RESOLUTION 2022-12-07

A RESOLUTION OF THE DOWNTOWN INVESTMENT AUTHORITY (“DIA”) APPROVING WITH CONDITIONS THE SITE PLAN FOR THE MUSEUM PARCEL, AS SHOWN IN EXHIBIT ‘A’; PROVIDING THE DIA CHIEF EXECUTIVE OFFICER (“CEO”) WITH THE AUTHORITY TO ADMINISTRATIVELY APPROVE MINOR CHANGES TO THE LOCATIONS OF ENTRANCES AND EXITS, BUILDING DIMENSIONS, AND USES AND ENGAGEMENT OF THE MUSEUM PARCEL ON BAY STREET AND THE RIVERFRONT; PROVIDING GUIDANCE TO THE DOWNTOWN DEVELOPMENT REVIEW BOARD (“DDRB”) AS TO THE DIA’S EXPECTATION ON BUILDING DESIGN FEATURES, RELATIONSHIP TO THE PARTNERSHIP AND PARK PARCELS, AND ACTIVATION; AUTHORIZING THE CEO OF THE DIA TO TAKE ALL ACTION NECESSARY TO EFFECTUATE THE PURPOSES OF THIS RESOLUTION; PROVIDING FOR AN EFFECTIVE DATE.

MOSH GENESIS DIA CONCEPT REVIEW

CONCEPT PLAN

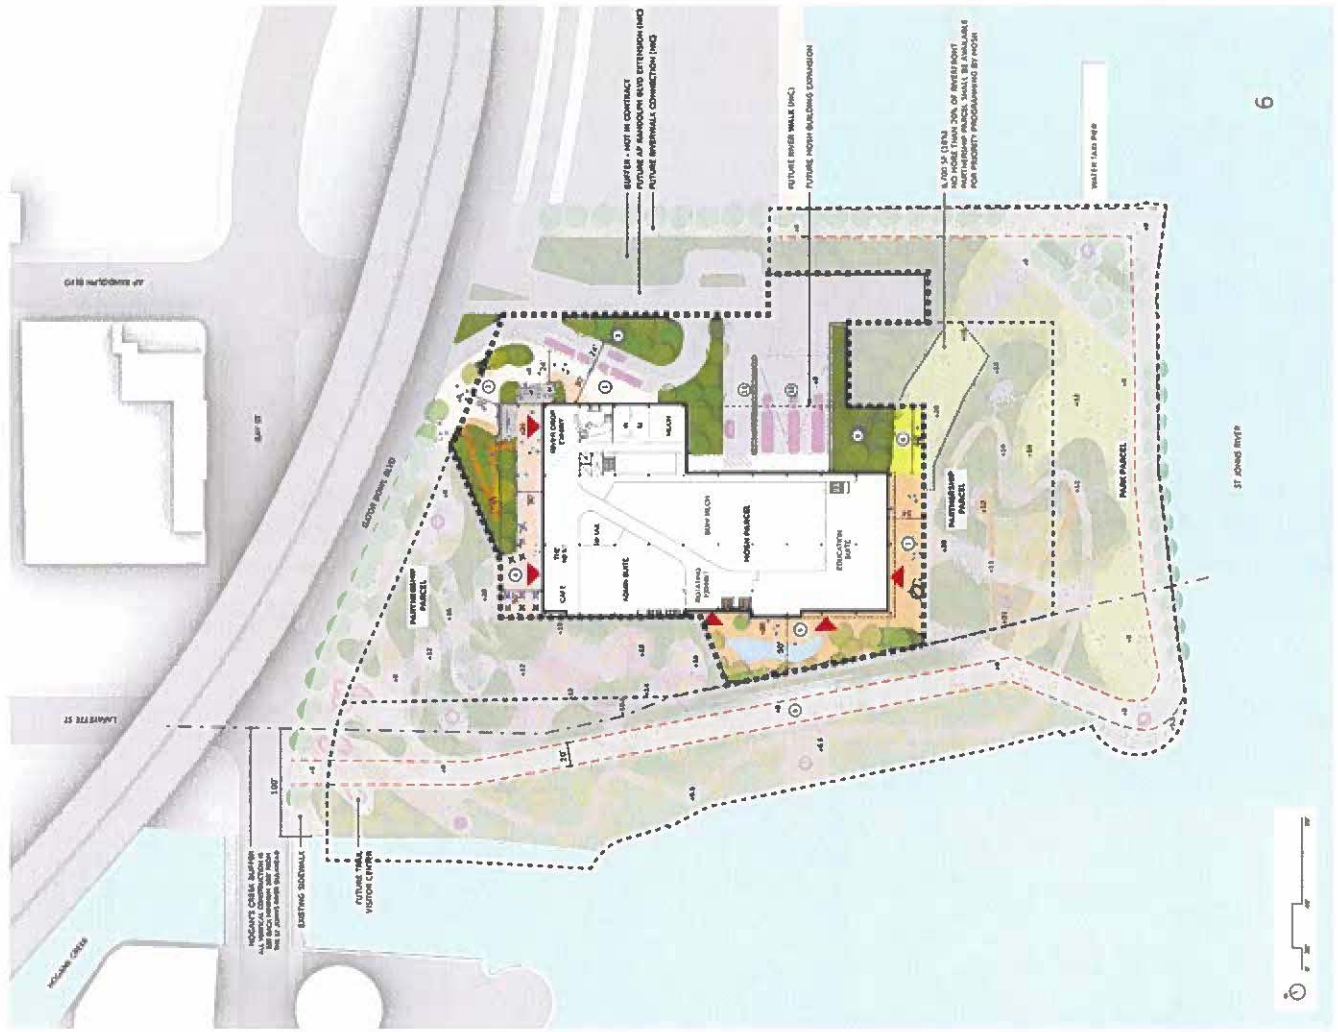
6. The continuous right-turn lane from Bay Street into the bus drop-off loop shall be removed. Entrance to the site shall be via A Philip Randolph Boulevard, however a right turn lane at the signalized intersection may be allowed subject to traffic Engineering approval.

MUSEUM ENTRANCE

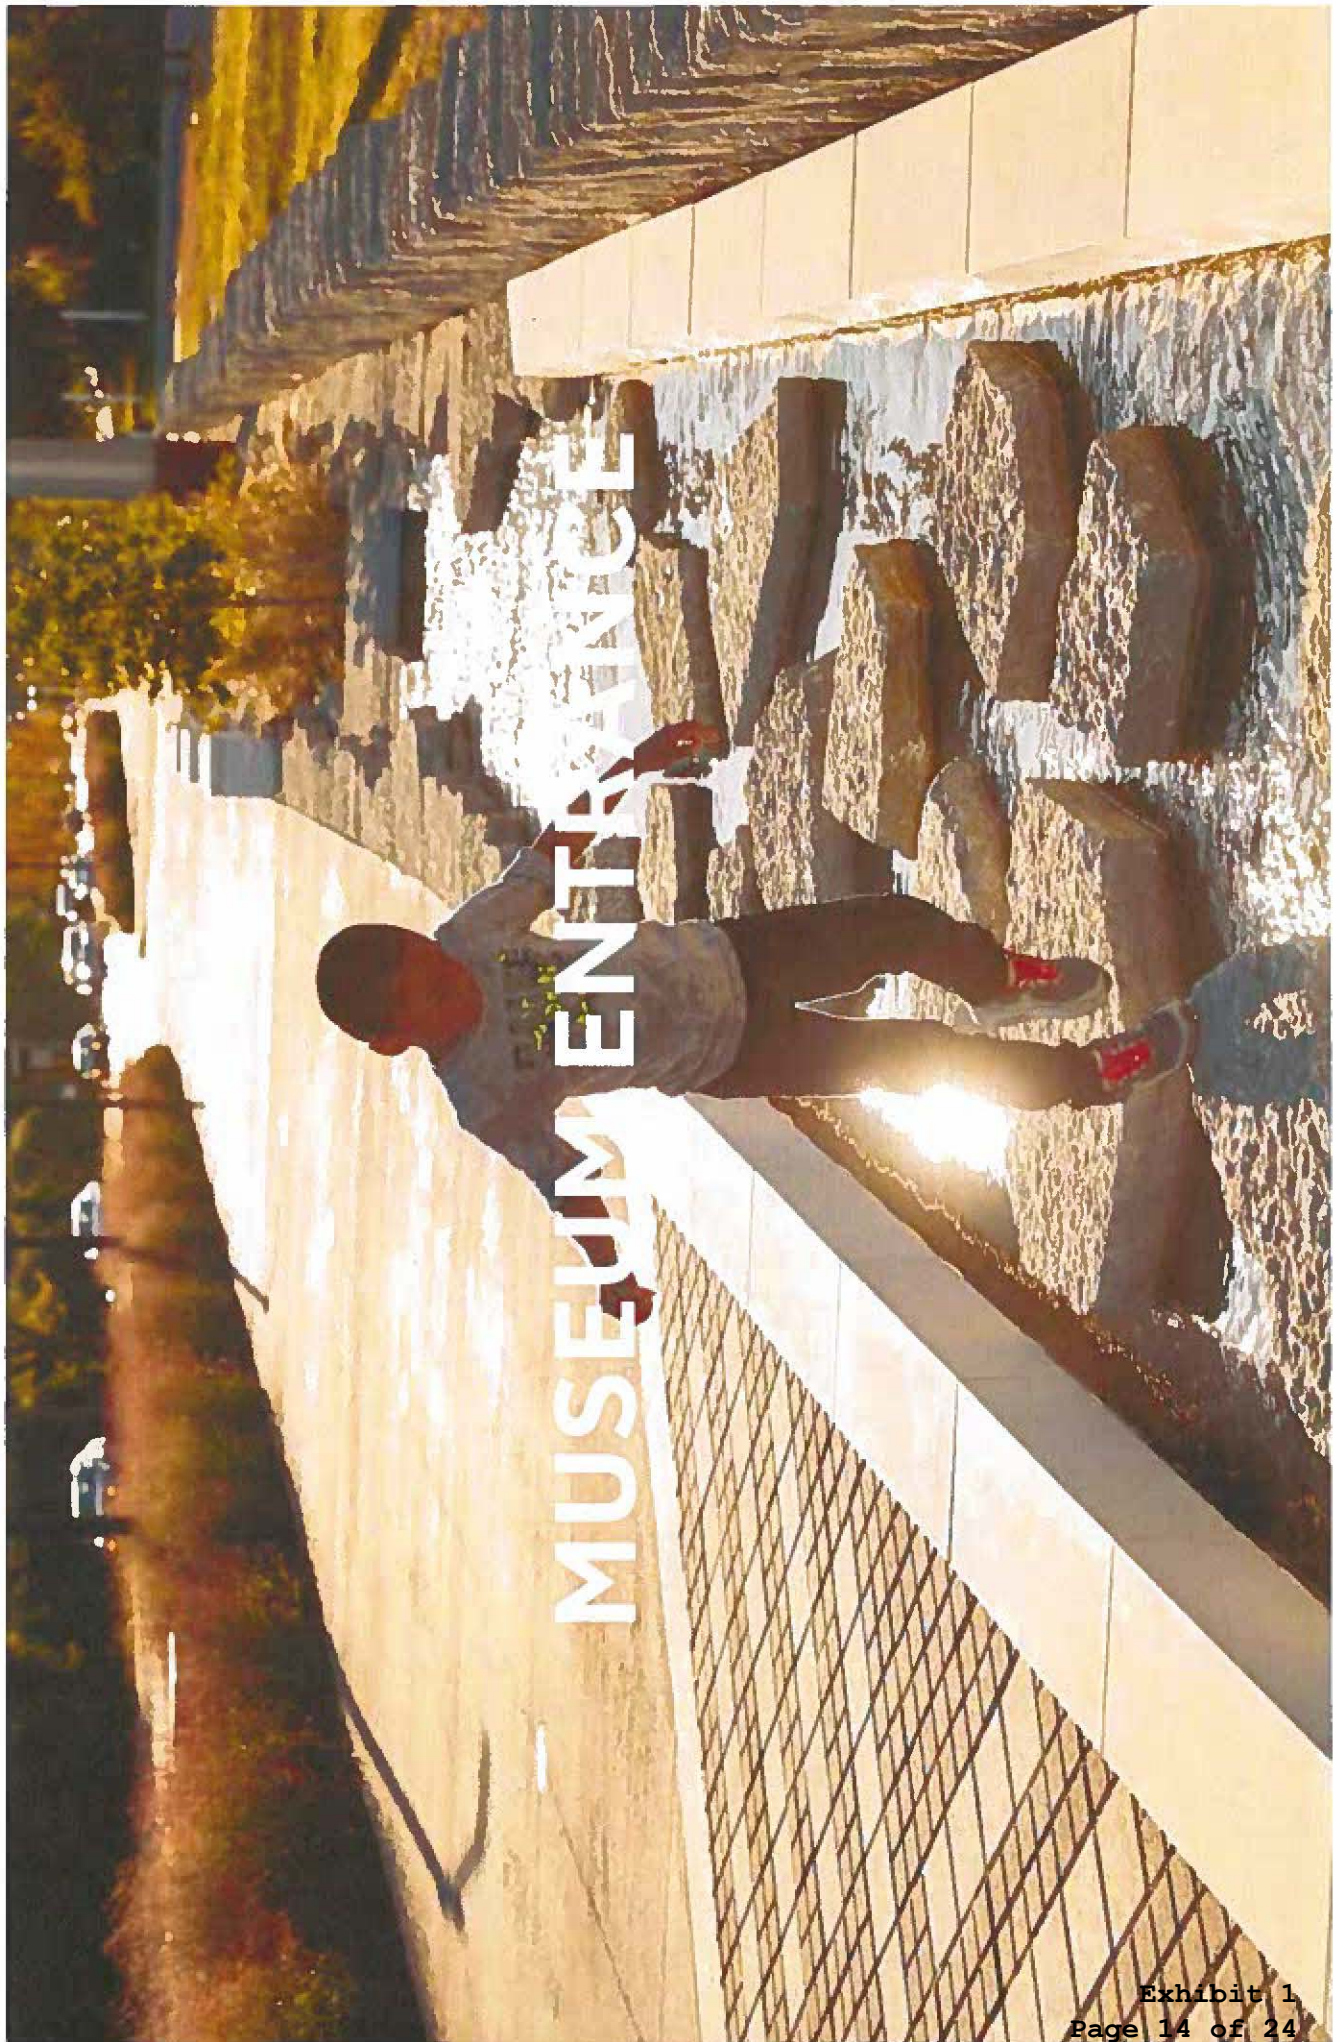
1. Building egress points to Bay Street and the St. Johns River shall be prominent and have a direct, external connection to each other with the intention that these access points ensure a strong relationship between the building and the site.

5. The Urban Open Space between the building and Bay Street shall feature public art or interactive equipment or installations (i.e., swings, exercise or play equipment, information kiosks, and/or similar features) for a curated pedestrian experience.

HIXON FLORIDA NATURALIST CENTER EXHIBIT & ST. JOHNS PORCH

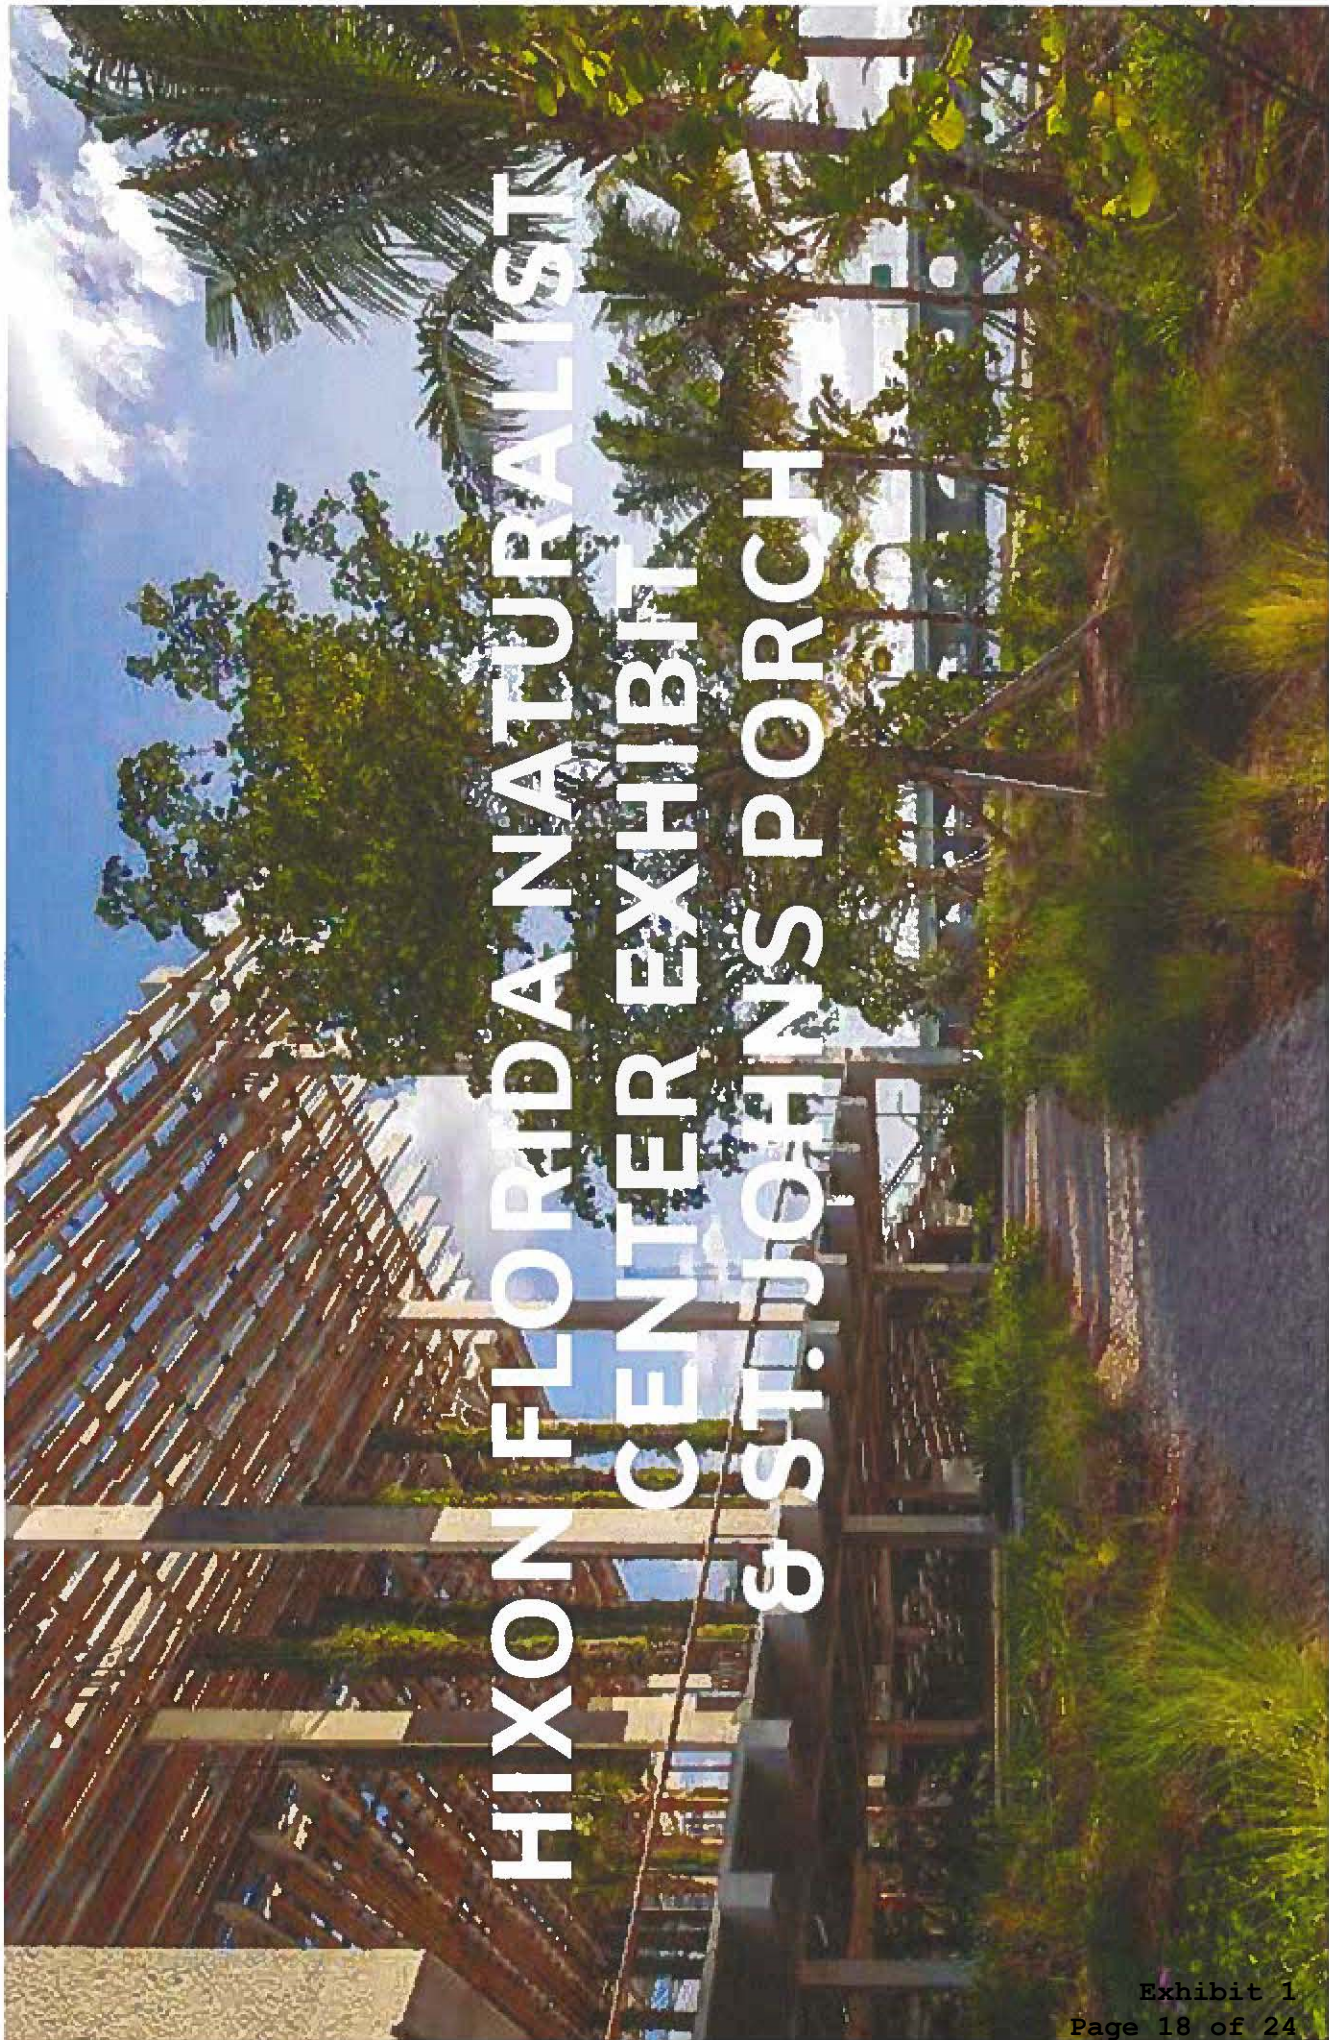
4. MOSH shall maximize transparency of, and minimize opacity of, the Hixon Exhibit space consistent with applicable wildlife (animal husbandry) regulations.
